Our reference: ECM Ref: 9796236
Contact: Kathryn Saunders
Telephone: (02) 4732 8567

Request for Advice - EIS – 155-217 Aldington Road Estate – SSD-17552047

Figure 3: Landscape section A-A. Excerpt from applicant's EIS.

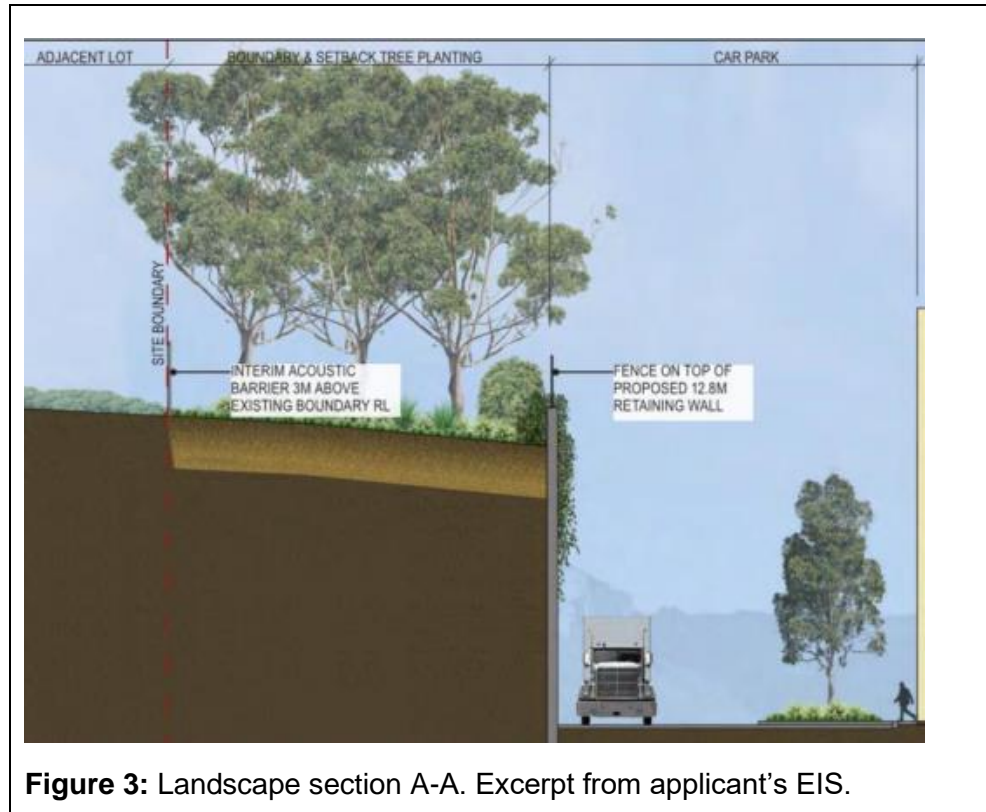
- (h) Signage is to be high quality and better documented and explained. The Mega Graphics are excessive and are considered advertising rather than business identification.
- (i) Trucks and domestic vehicles (staff and visitor) access and parking areas are to be separated.
- (j) Retaining walls are to be setback and stepped in accordance with the DCP requirements. Situations as depicted in Figure 3 below are to be avoided and redesigned.
- (k) Freight

- Several landscape cross sections are misleading, showing best case scenarios instead of worst case which are more relevant for assessment eg. 1m retaining walls instead of 7m at Lot 9. As such, trees should be setback further from walls of this height so they can develop appropriate and healthy branch structures - they are indicated as planted approximately 1m off the wall face.
